Consumer Product Service
Manager of Tehnical Support
TECH TIP

VCS
number 7

MODEL: CX5200

Defective Rockwell 6502 MPU on CX5200 PC Board.

Figure 1. CX5200 Schematic (R-C Network)

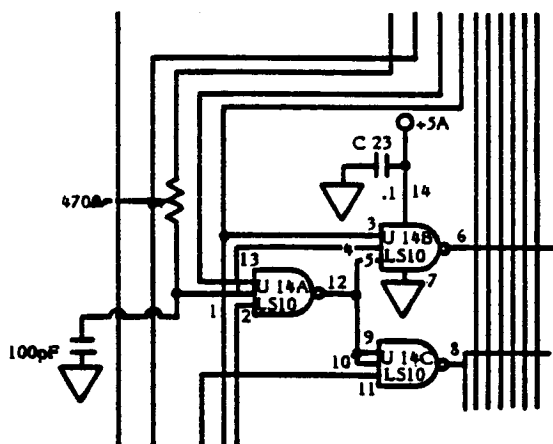
Rockwell MPUs with date code of 8250 and later (stamped with the letters RC) have a timing defect.

A factory modification adds an R-C network on the component side of the CX5200 PC Board at IC U14A (pin 1) and U6A (pin 4) (see Figures 1 and 2).

Figure 3. R-C Network (Add to solder side of CX 5200 PC Board)

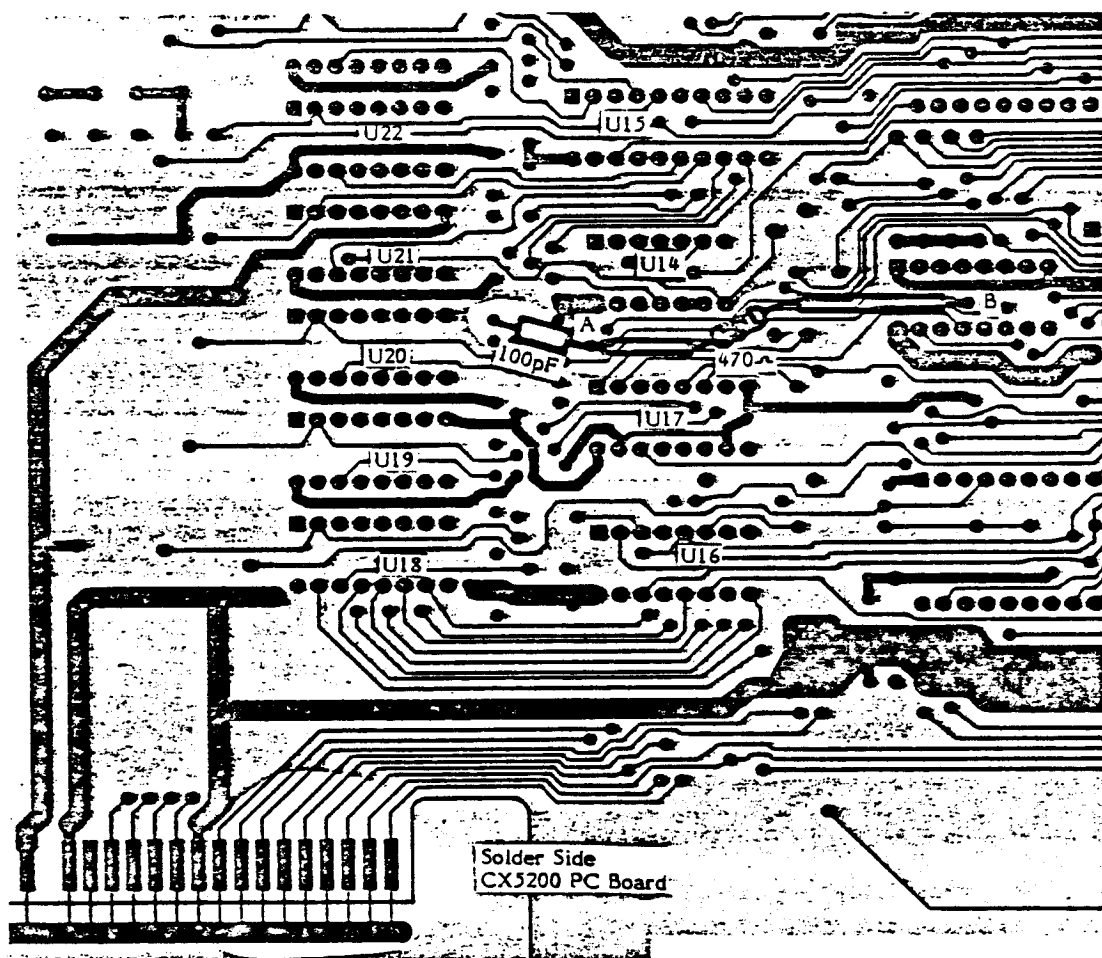
If you are installing an RC stamped 6502 on a CX5200 PC Board which has not had the factory modification added to the component side:

Add an R-C network to the solder side of the PC Board (See Figure 3).

See Figure 3 for the following steps:

1. Straighten the lead of C27 (solder side) and solder one lead of the 100 pf capacitor to it.
2. Point A is an unoccupied well between IC's U14 and U17. It is connected directly to Pin 1 of U14. Cut the trace running between points A and B as close to Point A as possible. Use a DVM to insure that the trace is now open.
3. Add sleeving to one lead of the 470 Ω resistor. Insert the lead into the well at Point A and solder.
4. Wrap the remaining lead of the 100 pf capacitor around the lead of the 470 Ω resistor at Point A and solder.
5. Remove the solder from well at Point B which is directly beneath U6. Add sleeving to the remaining lead of the 470 Ω resistor. Insert this lead into the hole at Point B and solder.
